DAVE'S FIRST ADDITION SUBDIVISION

APPLICATION NUMBER 3 DATE December 7, 2006

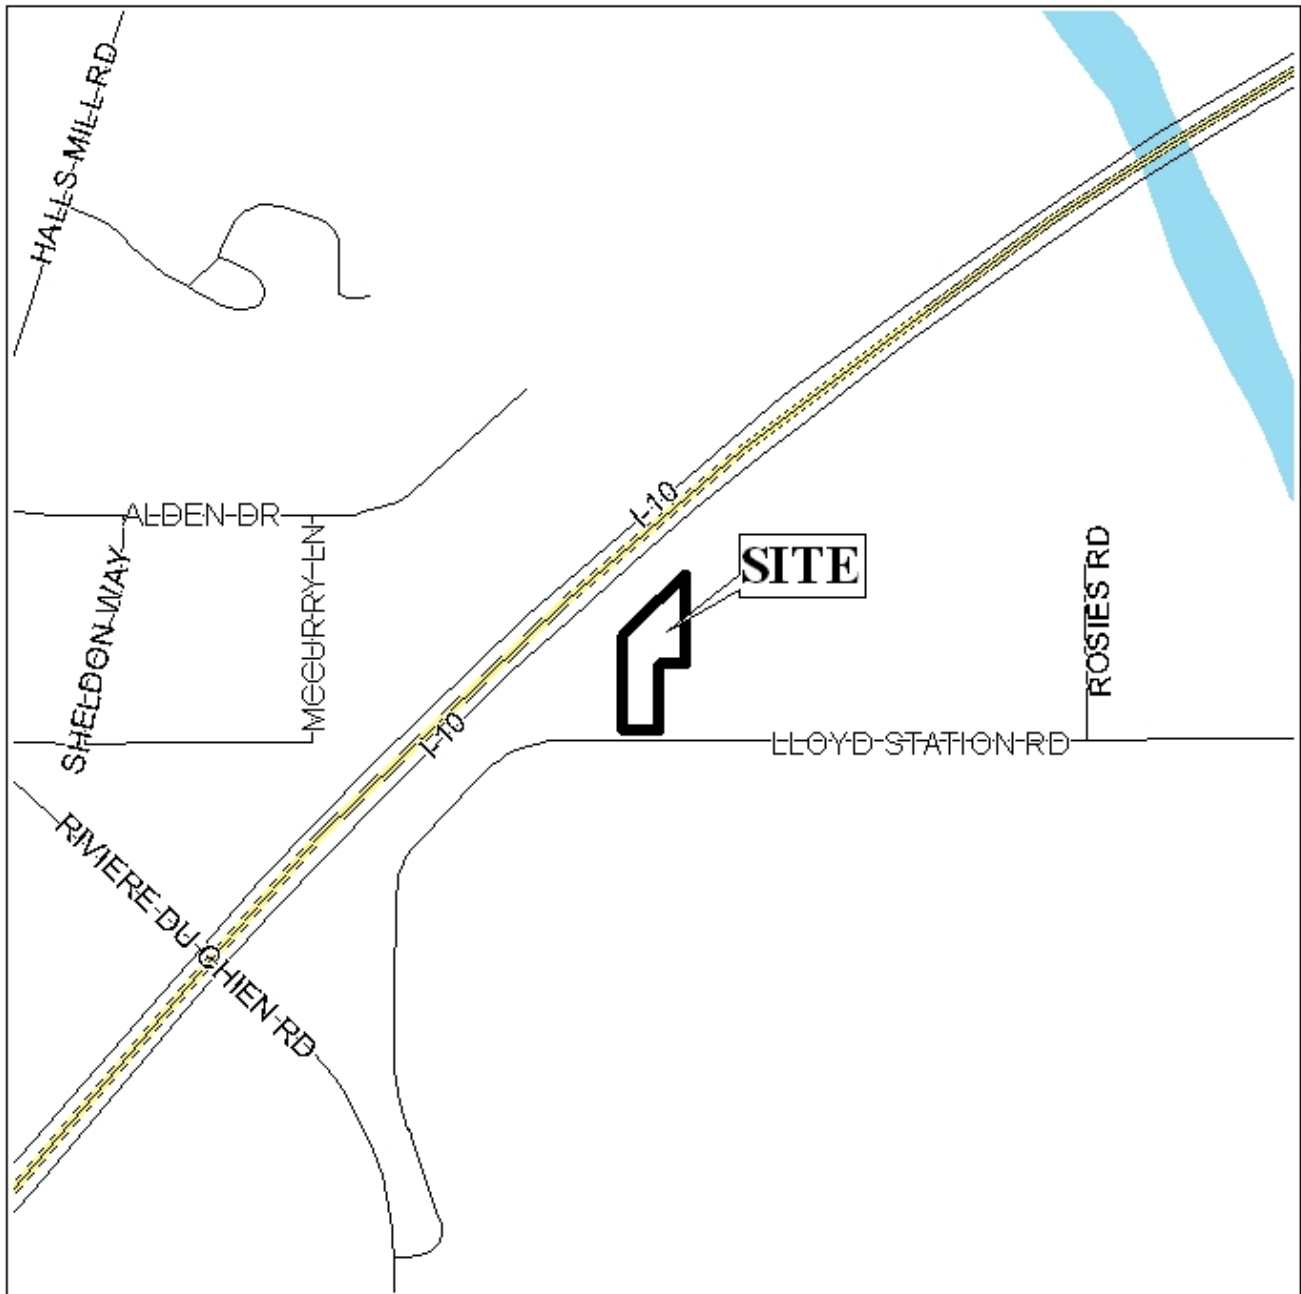
The 25' building setback line is not shown, but will be required on the final plat. It should be noted that there have issues in the past relating to the setback line and how it should be shown on flag lots. The staff position is that the setback should be "boxed" from the point where the "pole" meets the lot, providing 25' clear in all directions from that point.

Based on the preceding, it is recommended that Section V.D.3 be waived and the plat be granted Tentative Approval, subject to the following condition: 1) placement of the required 25' building setback line on the final plat.
